Device **TC29x**
Marking/Step **ES-BC, BC**
Package **see Data Sheet**

This Errata Sheet describes the deviations from the current user documentation.

Figure 3 Message RAM Configurations

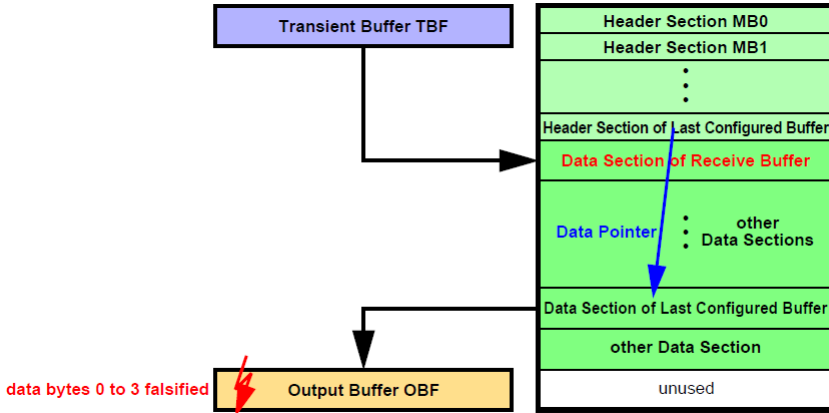
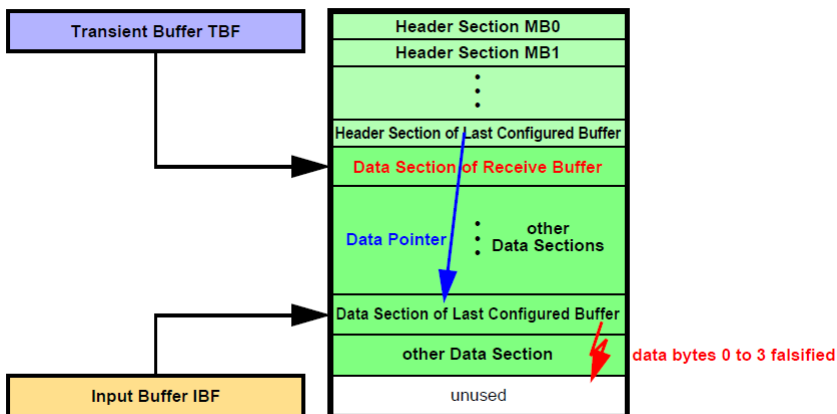
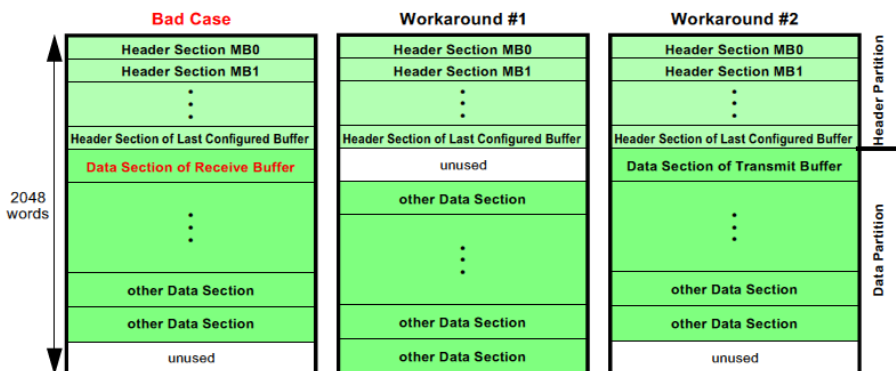
a) Message buffer transfer from Message RAM to OBF

When the message buffer has its payload configured to maximum length (PLC = 127), the OBF word on address 00h (payload data bytes 0 to 3) is overwritten with unexpected data at the end of the transfer.

b) Message buffer transfer from IBF to Message RAM

After the Data Section of the selected message buffer in the Message RAM has been written, one additional write access overwrites the following word in the Message RAM which might be the first word of the next Data Section.

The erratum is limited to the case when (see [Figure 3](#) “Bad Case”):

- a) When a message is transferred from the Last Configured Buffer in the Message RAM to the OBF and **PLC = 127** it may happen, that at the end of the transfer the OBF word on address 00h (payload data bytes 0 to 3) is overwritten with unexpected data (see [Figure 1](#)).
- b) When a message is transferred from IBF to the Last Configured Buffer in the Message RAM, it may happen, that at the end of the transfer of the Data Section one additional write access overwrites the following word, which may be the first word of another message's Data Section in the Message RAM (see [Figure 2](#)).

2) Ensure that the Data Section directly following the Header Partition is assigned to a transmit buffer.

Figure 6 Timing of LVDS TX interface command sending in relation to IRQ.IFCFS

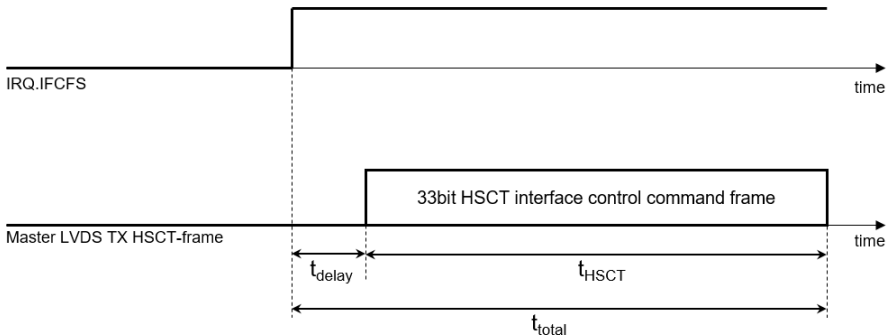
the user might falsely assume that also the actual sending on the LVDS TX port has already occurred once the IRQ.IFCFS flag is set, which is not true.

Instead the timing shown in **Figure 6** applies.

Figure 8 Alert Interrupt Behavior in case of Bus-Off

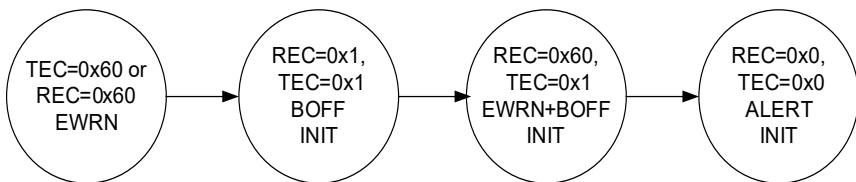
The MultiCAN module shows the following behavior in case of a bus-off status:

When the threshold for error warning (EWRN) is reached (default value of Error Warning Level EWRN = 0x60), then the EWRN interrupt is issued. The bus-off (BOFF) status is reached if TEC > 255 according to CAN specification, changing the MultiCAN module with REC and TEC to the same value 0x1, setting the INIT bit to 1_B, and issuing the BOFF interrupt. The bus-off recovery phase starts automatically. Every time an idle time is seen, REC is incremented. If REC = 0x60, a combined status EWRN+BOFF is reached. The corresponding interrupt can also be seen as a pre-warning interrupt, that the bus-off recovery phase will be finished soon. When the bus-off recovery phase has finished (128 times idle time have been seen on the bus), EWRN and BOFF are cleared, the ALERT interrupt bit is set and the INIT bit is still set.

Table 59 Register PMSWSTAT - Bits 19:16

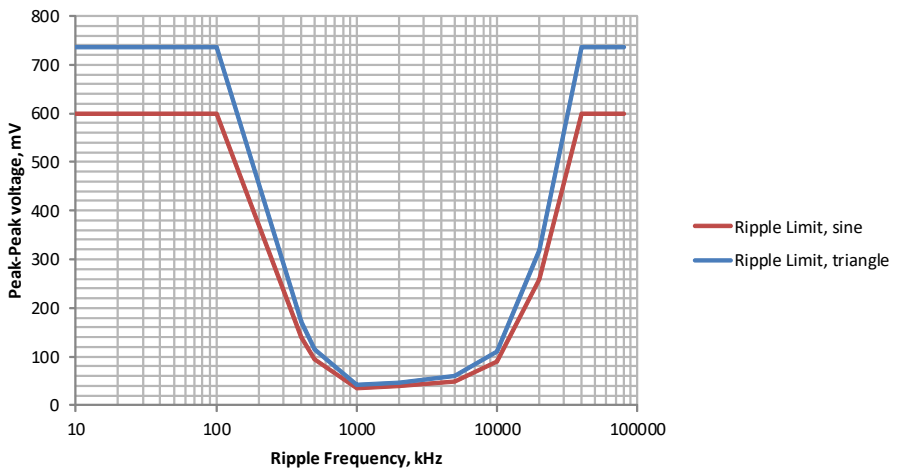
In the description of the Standby and Wake-up Status Flag Register (PMSWSTAT) in the User's Manual, bit PMSWSTAT.16 is erroneously shown as 0_B .

As the reset value of PMSWSTAT.16 = 1_B , the correct description of bit 16 in PMSWSTAT is as shown in **Table 59** below:

Field	Bits	Type	Description
Res	16	r	Reserved Read as 1
0	19:17	r	Reserved Read as 0

Figure 14 SENT Tolerance of this Design Step

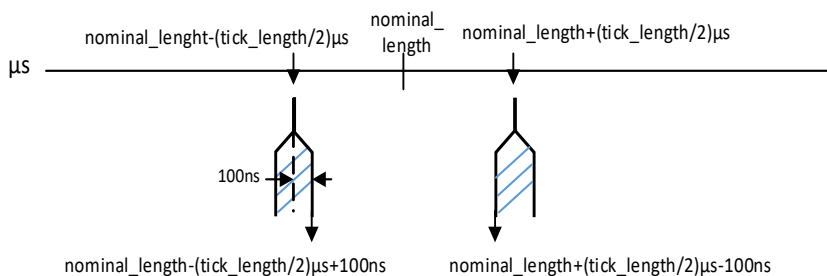
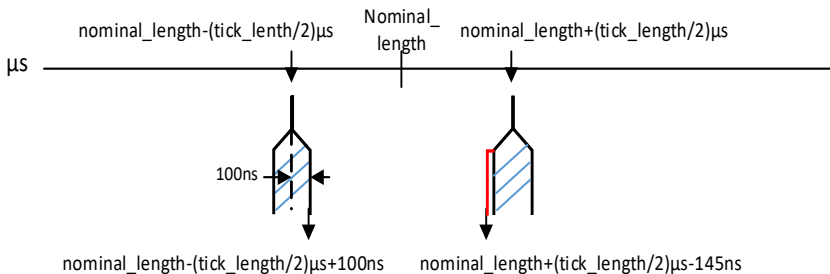
The length of a nibble in the SENT protocol determines the value of this nibble. For each value this length can vary, but it has to be at least inside a given range. This range is given by the SENT standard.

- The lower border is $\text{nominal_value} - (\text{tick_length}/2) \mu\text{s} + 100 \text{ ns}$
- The upper border is $\text{nominal_value} + (\text{tick_length}/2) \mu\text{s} - 100 \text{ ns}$.

In this design step the range is delimited as follows:

- The lower border is $\text{nominal_value} - (\text{tick_length}/2) \mu\text{s} + 100 \text{ ns}$
- The upper border is $\text{nominal_value} + (\text{tick_length}/2) \mu\text{s} - 145 \text{ ns}$.
